La Puesta del Sol Unit Three

City of El Paso — City Plan Commission — 12/6/2018

SUSU18-00068 — Major Preliminary

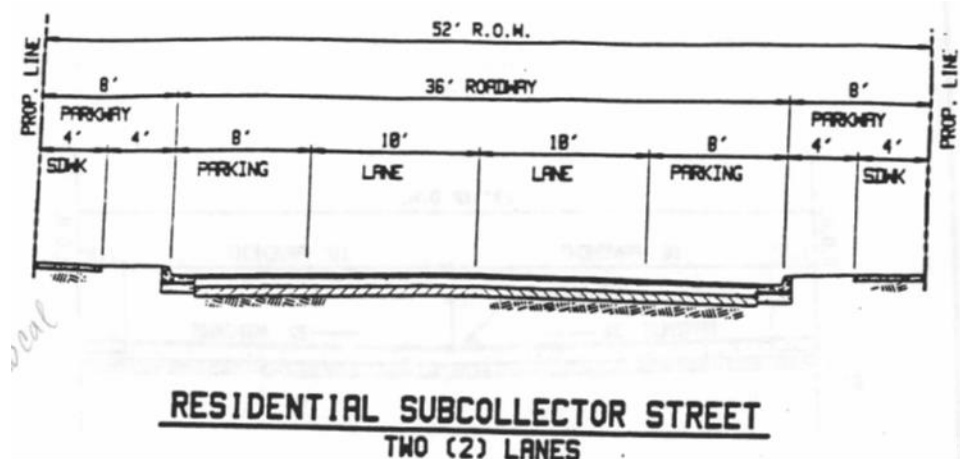
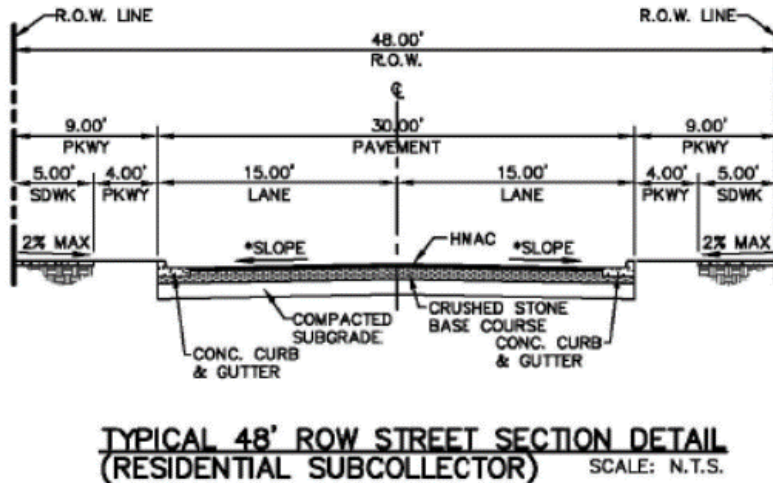
- The applicant is requesting the following modification requests pursuant to Section 19.04.170 of the former subdivision code:
 1. To allow a 48' ROW with 30' of pavement, 4' landscape and 5' sidewalk.

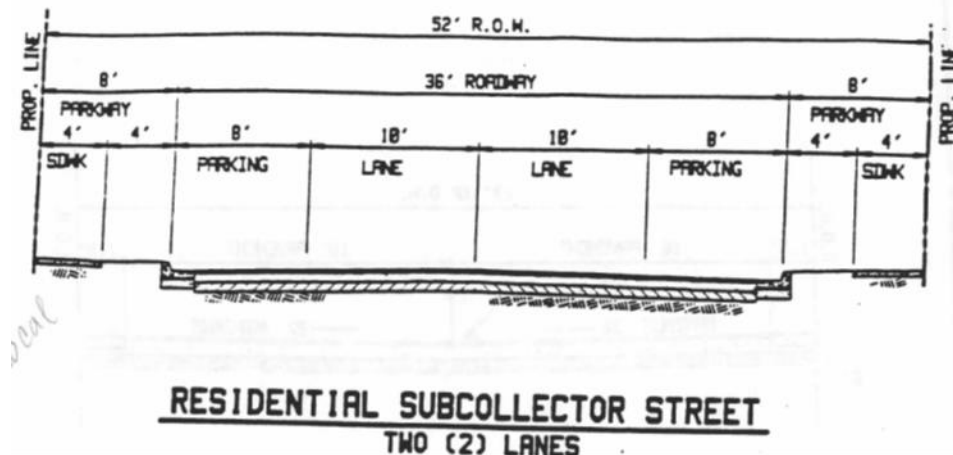
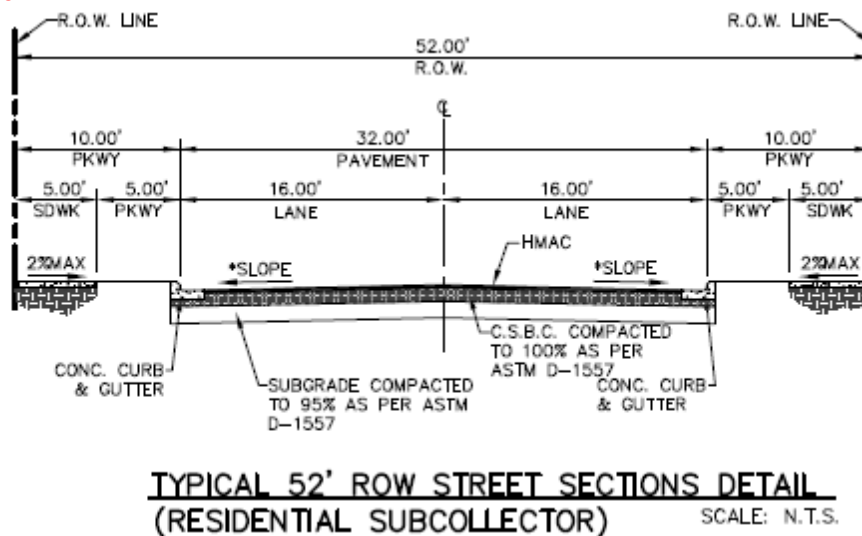
- To allow a 52' ROW with 32' of pavement, 5' landscape and 5' sidewalk

ATTACHMENT 2

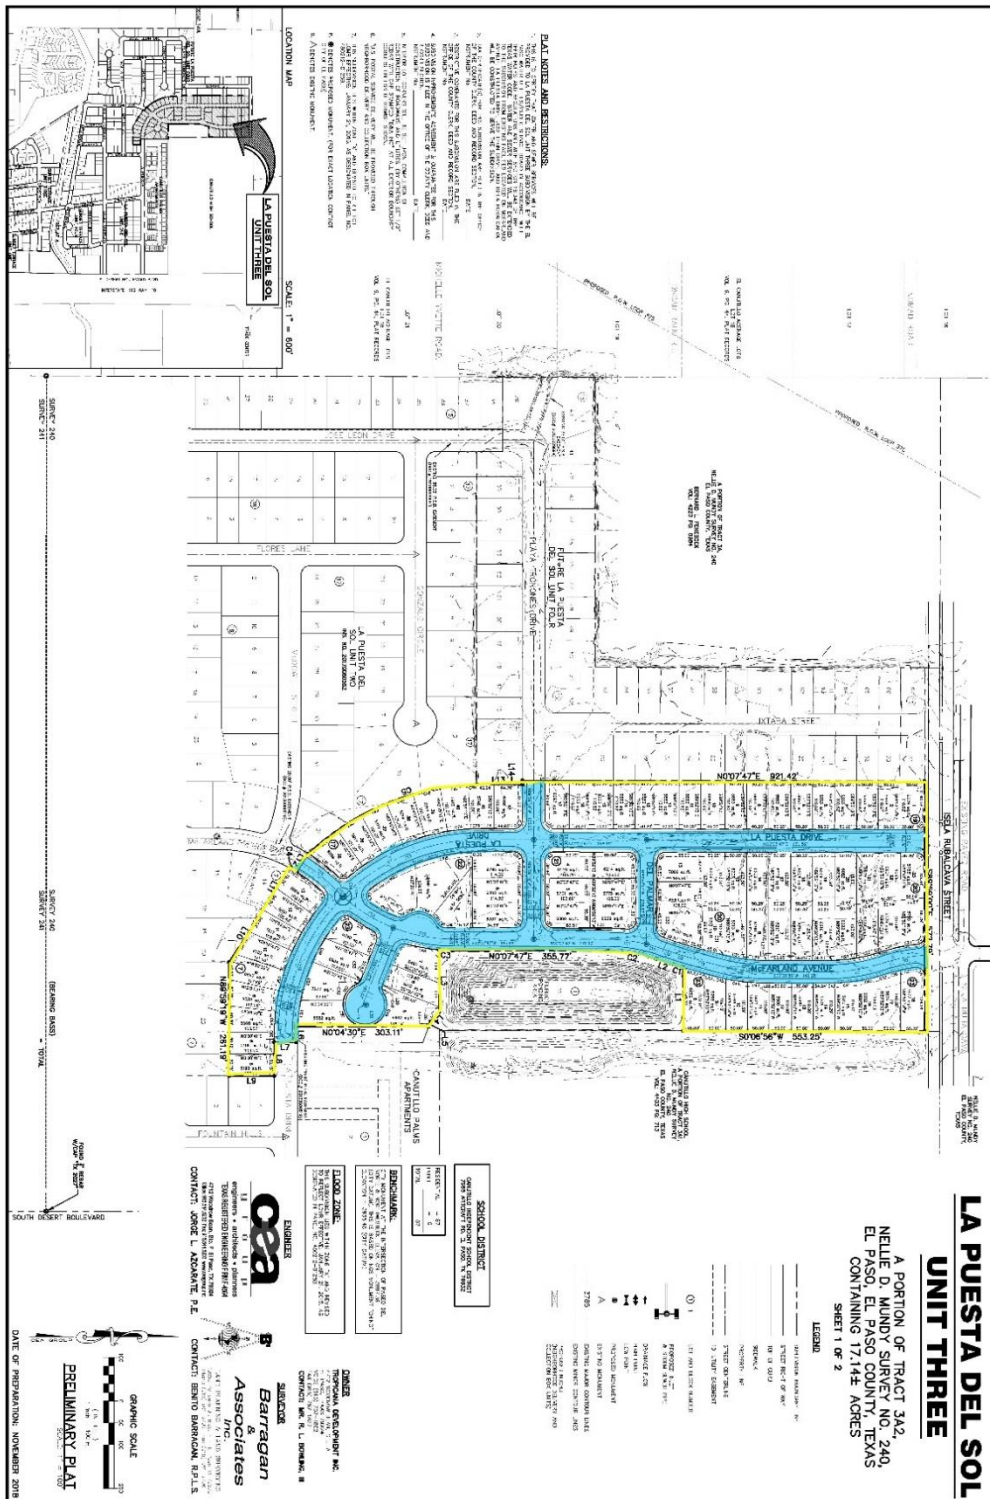
1. The subdivision shall be tied to a horizontal control by bearing and distance to either a section corner, survey line, the National Geodetic Survey monument, City monument, or other known and accepted survey points. This tie shall be delineated on the plat.

Consider changing the name of La Puesta Dr north of McFarland Ave so there are not 300s south of Mc Farland and 6600s north of McFarland? I would like to request that a new street name be added to the cul de sac at block 21. Otherwise, please change the addressing for block 21 from the 300 range to the 6600 range
